**SOUTH HADLEY PLANNING BOARD VIRTUAL MEETING
MINUTES OF SEPTEMBER 14, 2020
As Approved**

Application for Definitive Plan and Stormwater Management Permit approval for proposed 'North Pole Estates' subdivision located at west side of Hadley Street (aka State Route 47) and along Sullivan Lane (Assessor's Map Number #54 as Parcels #15 & #20 and on Assessor's Map Number #56 as Parcels #20, #26, #42, #43, #43A, #104, #109, #112, and #121).

Mr. Harris overviewed the status of the applications and the expectations for tonight's hearing. The applications for development of the proposed North Pole Estates Subdivision were peer-reviewed to evaluate their conformity to the Town's Bylaws and existing regulations. The peer-review separately evaluated the stormwater management plan, the hydrological assessment study, the traffic impact study, and the Definitive Subdivision Plan itself. For the ease of review, the peer-review consultant compiled their initial comments and subsequent response comments into a matrix. The focus of tonight's public hearing session was to review the Definitive Subdivision Plan component of the matrix while the peer-review consultant was present to offer clarity whe

Comparison of Proposed Layout in Preliminary and Definitive Plan Phases

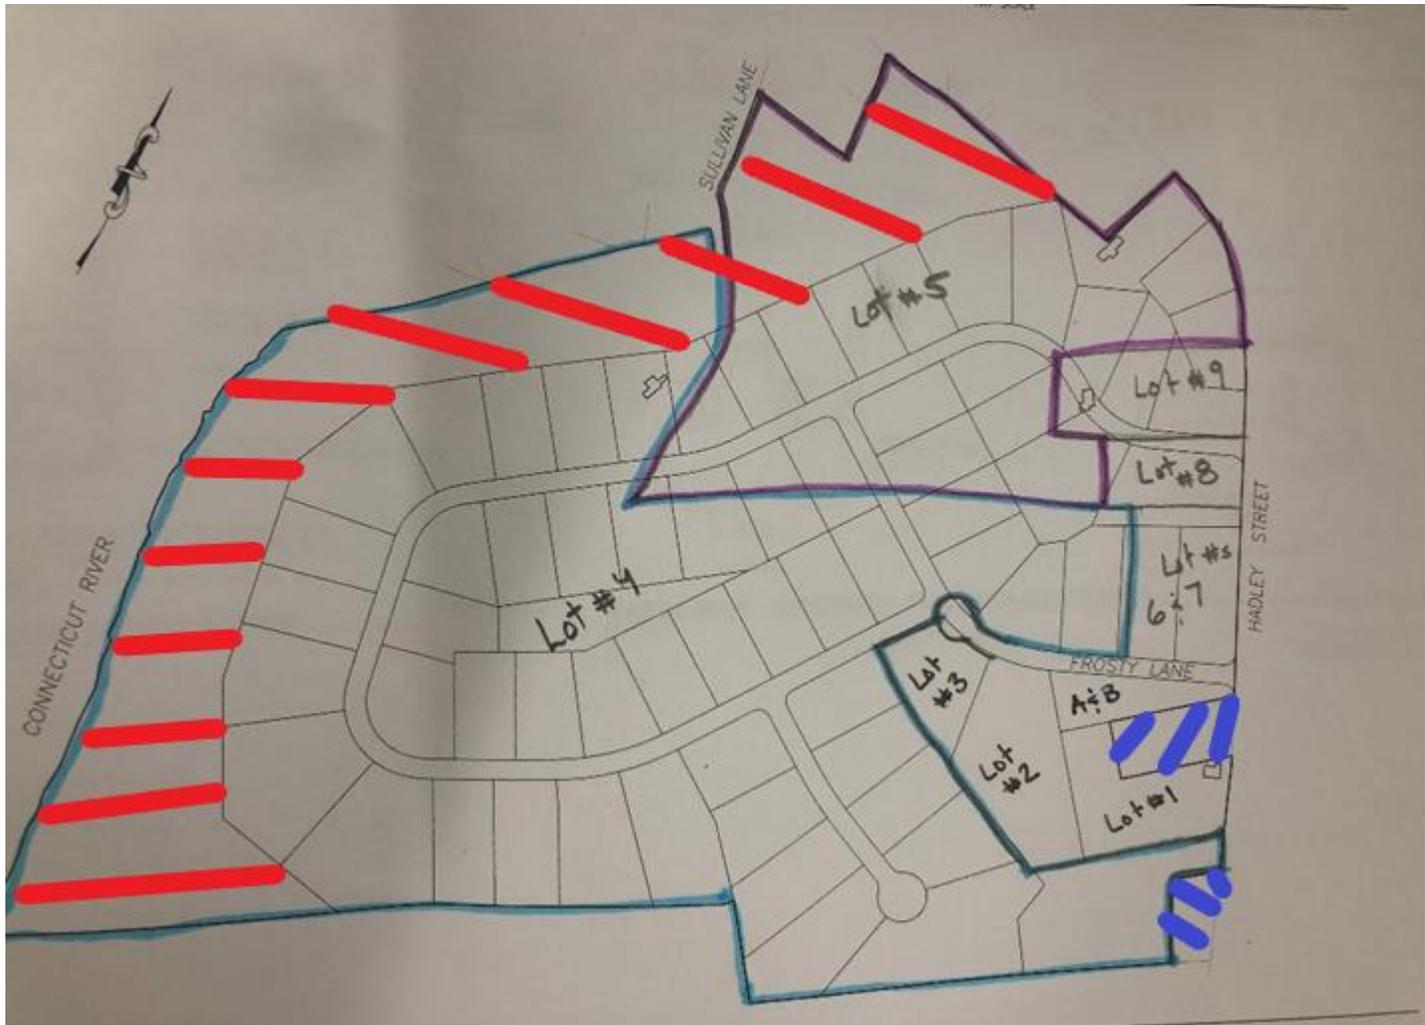
Chair Hutchison referenced a map provided by the peer-review consultant which sought to compare the Preliminary Plan and the Definitive Plan. It would have been helpful for the applicant to provide a plan of the Definitive Subdivision Plan with an overlay of the Preliminary Plan. Mr. Harris explained that this information would allow the Board to see if all property shown in the Preliminary Plan was within the Definitive Plan because any zoning freeze associated with the Preliminary Plan only pertained to land within that approved boundary. It had been identified that there were portions of property currently owned by Peter Edge that were within the Definitive Plan but not within the Preliminary Plan. Rob Levesque would provide an overlay as requested.

The Board previously touched upon this item. The applicant would provide an overlay of the Preliminary Plan over the Definitive Plan. The Riverfront boundary delineation had been provided previously. The peer-review indicated that only street grading was provided. Grading for the full site was not shown. Rob Levesque stated that there would be no grading outside of the lot with homes shown with the exception of the two ANR. Clerk Brown asked for more information on the new ANR lots that were mentioned. Rob Levesque responded that two ANR lots could be created along the north side of Frosty lane.
